ADDENDUM # 3

Project	TA Blakelock High School Renovations	Project No.	2215-B
Location	1160 Rebecca Street, Oakville, ON	Date of Issue	2024 04 26
Owner	Halton District School Board	File	2215/7.1.3

This Addendum forms part of the Contract Documents and amends the original Drawings and Specifications, dated 2024 04 11, and all preceding Addenda, as noted below.

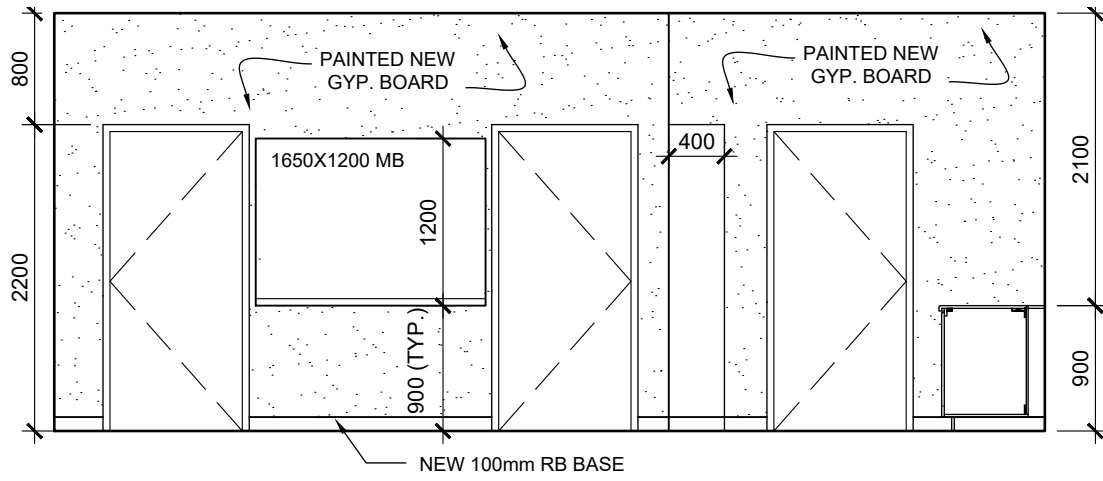
8. Q: Mechanical drawing shows radiator in RM 213/214 to remain, however architectural drawings show demo and disposal. Please confirm scope.

A: The radiators in RM 213/214 are to remain.

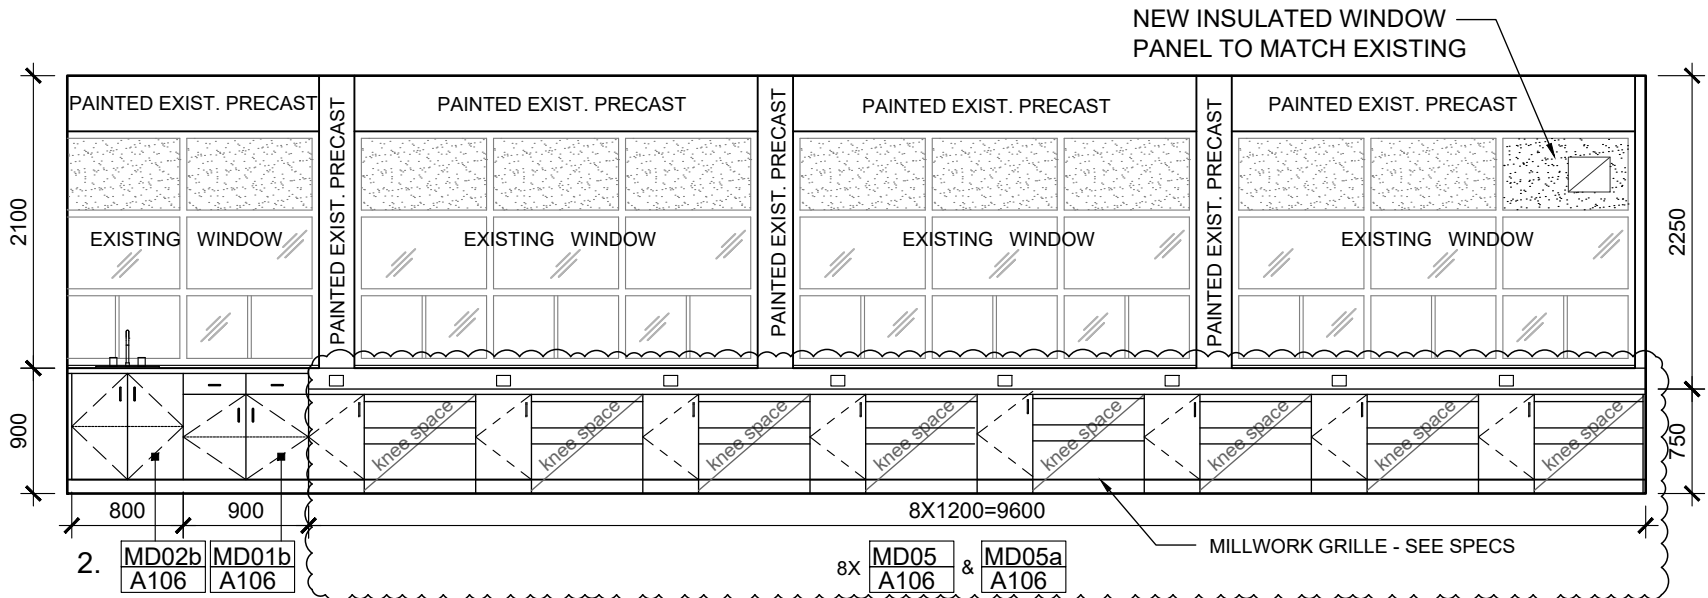
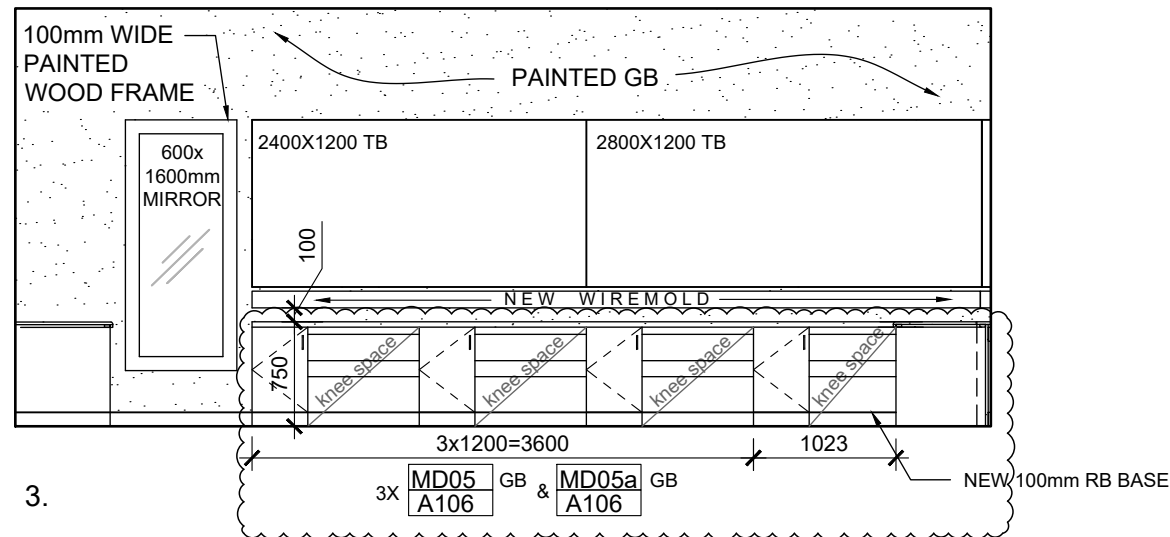
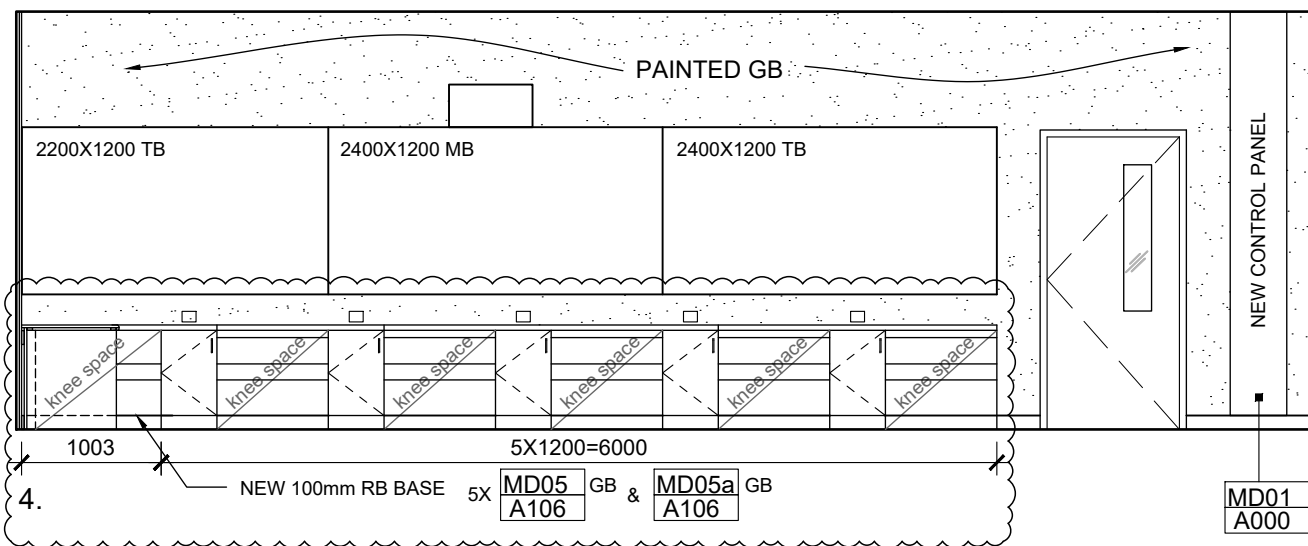
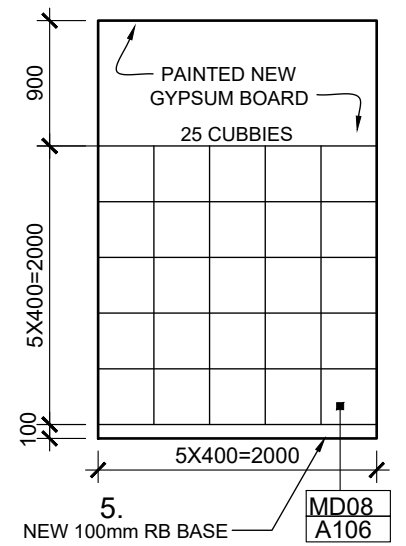
5. Drawing SKA-03 (Part of Drawing A103)

- .1 Interior elevations 2, 3, & 4 were revised to reflect the millwork changes.
- .2 Wire mold was deleted and replaced with recessed receptacles at interior elevation 2 & 4.

3 AREA 3 - RENOVATION POWER

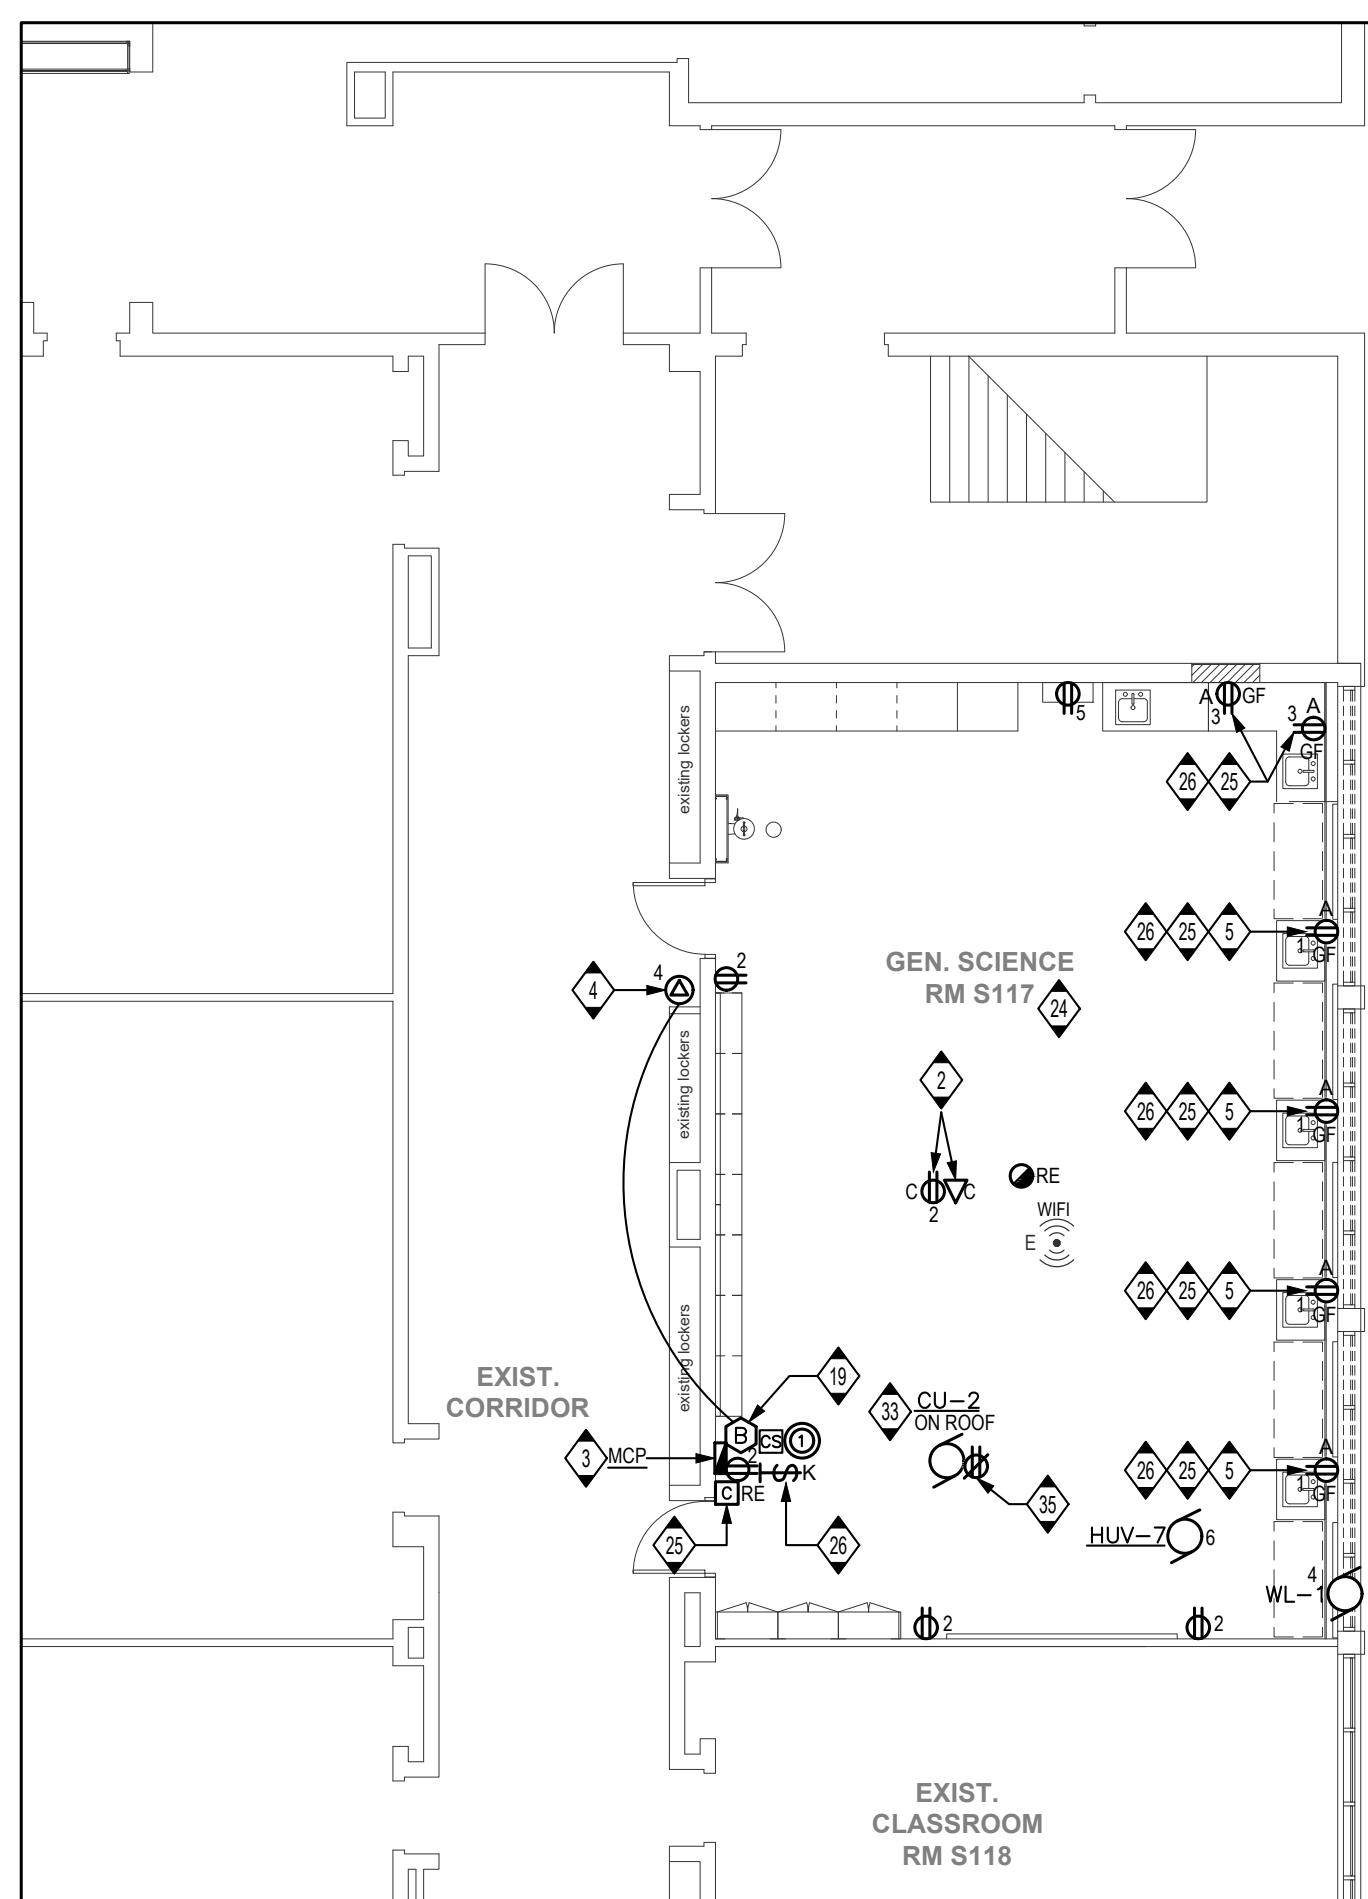
3. **Drawing E301 – LEVEL 0 & 1 POWER & SYSTEM RENOVATION PLANS**
 - .1 Drawing is issued with this addendum. Modifications include, but are not limited to the following:
 - .2 **Refer to 4/E300 – AREA 3 - RENOVATION POWER**
 - .1 **REMOVE** the recessed raceway along the East and West walls.
 - .2 **ADD** duplex receptacle recessed at every sewing station along the East and West wall.
 - .3 **REVISED** recessed raceway along the South wall.

- DUPLEX RECEPTACLES RECESSED AT EVERY SEWING STATION LOCATION. REFER TO ARCHITECTURAL DRAWINGS FOR EXACT LOCATION AND MOUNTING HEIGHT.
